**SERVICE BULLETIN**

**CANOPY LATCH CORRECT OPERATION INSPECTION**

T67C, T67M and T67M200 Aircraft, Post Mod M129 (Split Canopy), T67M-MkII, T67M260 and T67M260-T3A.

Fig 1

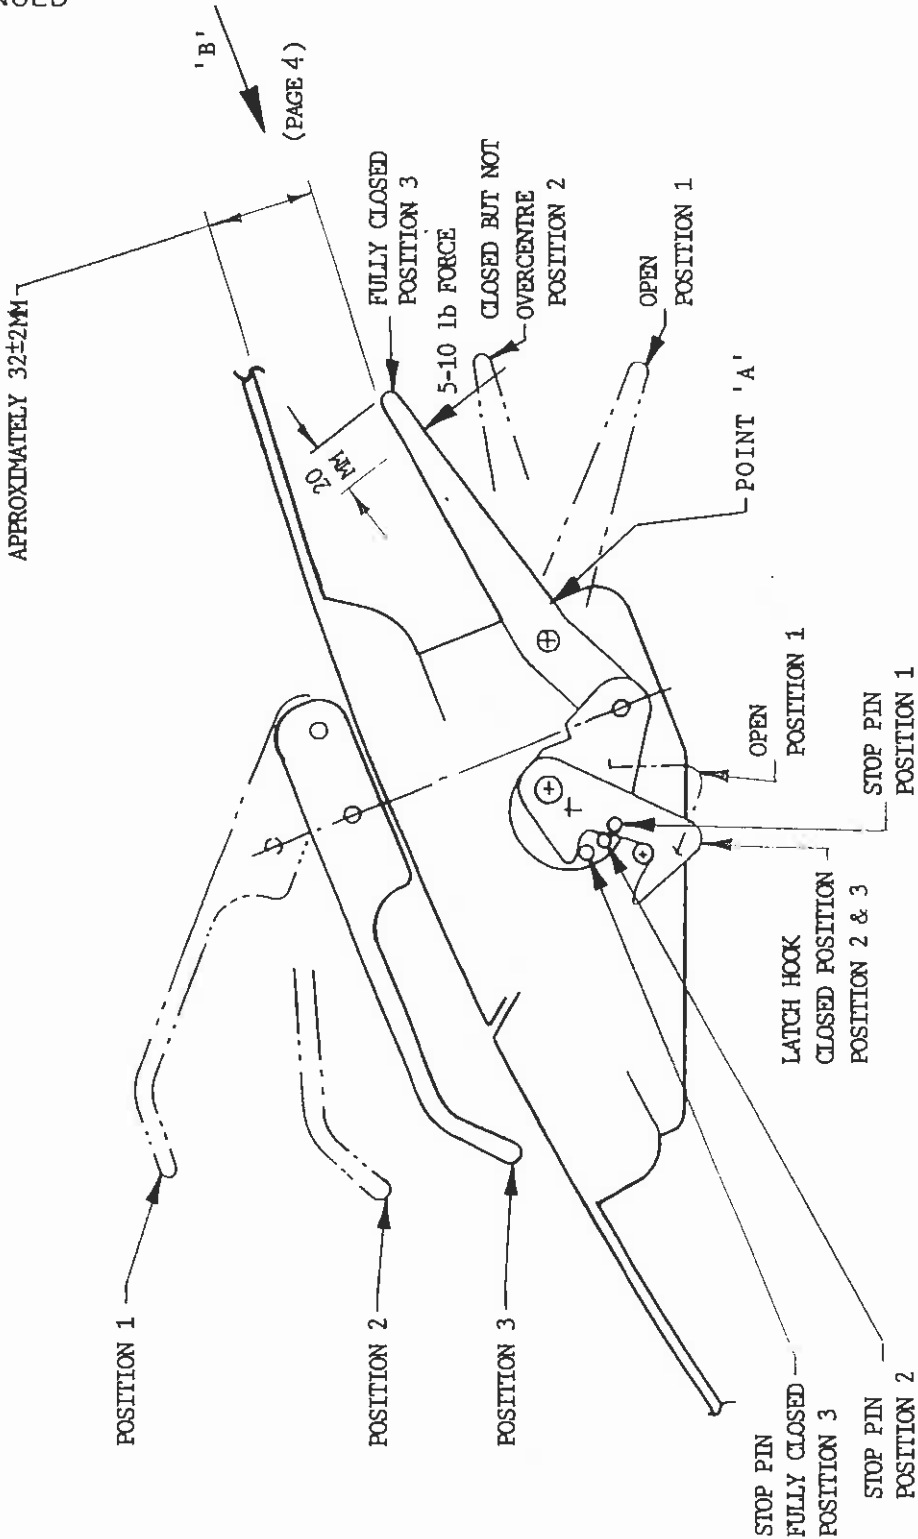
Fig. 1 page 2 shows 3 positions of the canopy mechanism:

Position 1 - Open/Unlatched

Position 2 - Latched but mechanism not over centre

Position 3 - Correctly closed, mechanism fully over centre.

- (i) Remove canopy mechanism and latch covers
- (ii) Close canopy fully. Ensure internal handle is in its correct position (Ref Fig.1).
- (iii) Check that stop pin is just touching latch hook. If not adjust in accordance with Maintenance Manual, Section 3, paragraphs 3.2.
- (iv) Check closure load is 5-10 lbs as indicated on Fig. 1.
- (v) Replace mechanism and latch covers, in accordance with Maintenance Manual, Section 3, paragraphs 3.2.
- (vi) Maintenance Manuals to be amended to reflect points contained in (ii), (iii) and (iv).

FIG 2  
VIEW ON ARROW 'B' (REF FIG 1)

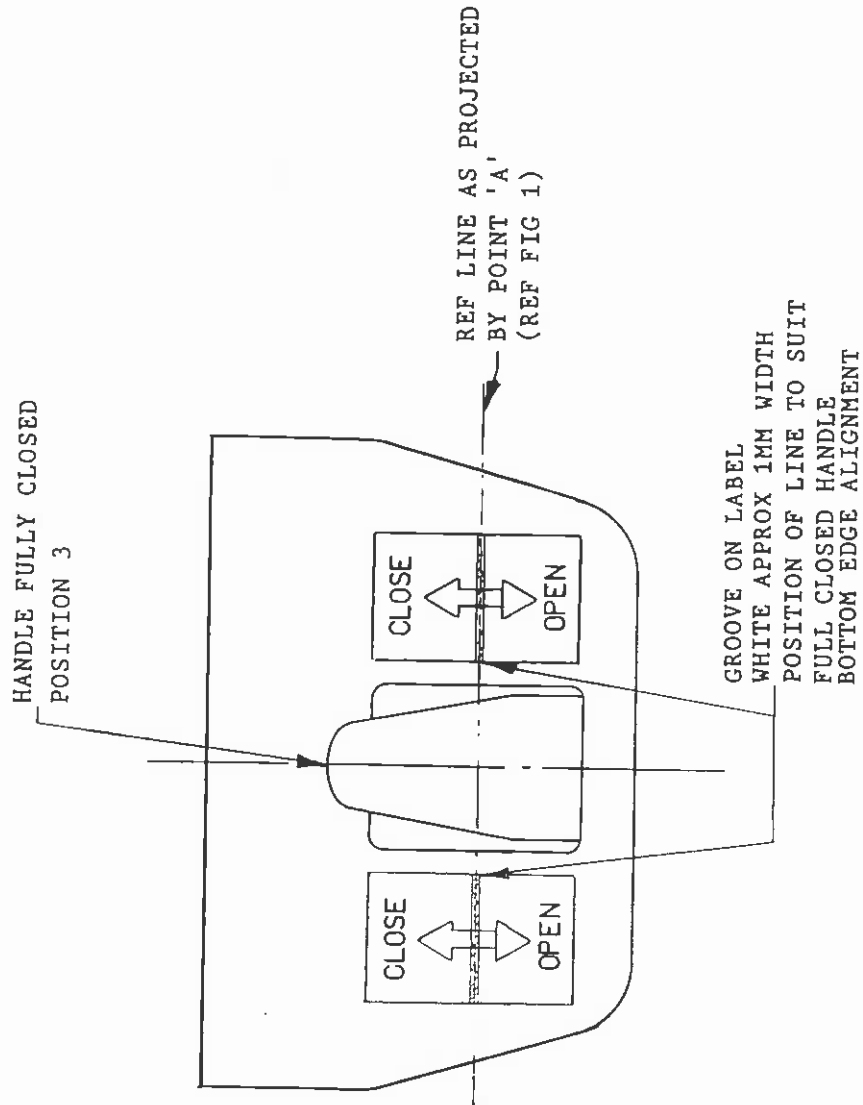
- (vii) When handle is fully closed, it meets requirements of Fig. 1, mark a white line across both labels ref. Fig. 2 on line with handle lower surface (ie coincident with Point 'A' ref Fig. 1 & 2. The line may be obtained by running a hacksaw across both labels; a) deep enough to reveal white of label material or b) if base material is red, deep enough to hold white fill in wax, ie 0.25mm to 0.5mm.

When label is marked, it is to be identified in IPC Ref. Chapter 15 as Part No. T67M-17-351 Post Mod M666, Part No. T67M-17-319 to be annotated Pre Mod M666.
